# RB173-22

IRC: R502.11 (New), R502.11.1 (New), 502.11.2 (New), 502.11.3 (New)

## **Individual Consideration Agenda**

### **Public Comment 1:**

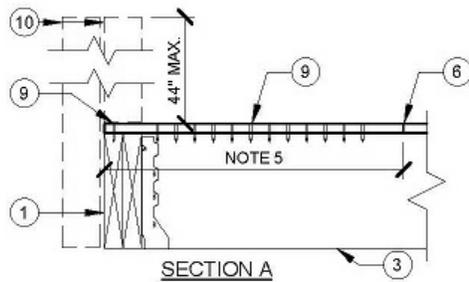
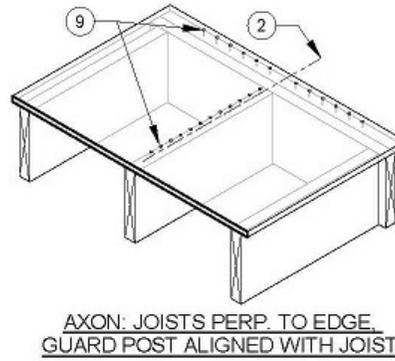
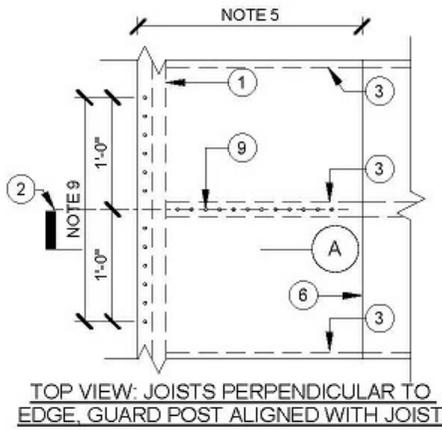
**R502.11.1 Conventional edge framing.** ~~Where a roll brace is aligned with each guard post, the~~ ~~The~~ framing at the edge of the floor shall consist of a solid or built-up ~~wood~~ member of lumber, structural glued laminated timber, or structural composite lumber having a minimum net width of 3 inches (76mm) and a minimum net depth of 9-1/4 inches (235 mm) and shall be braced to resist rotation by roll bracing as described in Section R502.11.3 ~~with a roll brace aligned with each guard post.~~

**R502.11.2 Timber edge framing.** ~~Where a roll brace is not aligned with each guard post, the~~ ~~The~~ framing at the edge of the floor shall consist of a minimum 6x10 sawn timber or a minimum 5-1/8 inch x 9-1/4 inch (130 mm x 235 mm) structural glued laminated timber and shall be braced to resist rotation by roll bracing as described in Section R502.11.3 at intervals of 48 inches (1219 mm) or less.

4. Some of the Committee members questioned that it was not clear that R502.11.1 does not preclude the use of Structural Composite Lumber. To clarify this the phrase "*...member of lumber, structural glued laminated timber, or structural composite lumber*" has been substituted for "*wood*" to specifically include these options. Structural composite lumber would include: LVL, PSL, LSL, or OSL. The drawings included for the commentary have also been clarified.

In the original published version of the monograph the drawings submitted with the proposal for inclusion in the commentary were not printed with the proposal. Although they were and continue to be accessed at the link provided in the reason statement they were requested by the committee to be included for the commentary. In the version of the proposal now available online the drawings have been included however the quality is poor. The drawings have been resubmitted with this proposal with the change to the drawing notes to clarify that of in addition to lumber, structural composite lumber is included as described in point 3 above.

**TOP VIEW: JOISTS PERPENDICULAR TO  
EDGE, GUARD POST OFFSET FROM JOISTS**

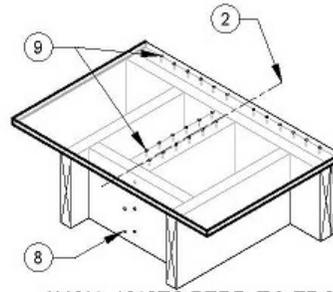
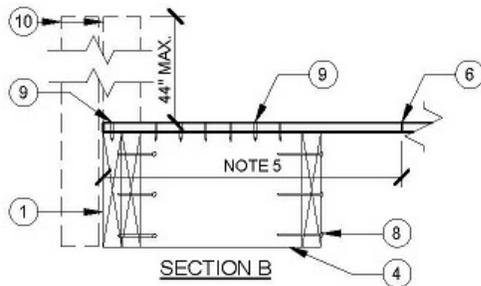
3. Questions from the committee and testimony inquired as to the difference between the application of R502.11.1 and R502.11.2. The purposeful application of each section has been clarified by moving the text related to the *alignment of roll bracing with the guard posts* to the beginning of both sections to clearly establish and differentiate the dependent condition for use of each section.
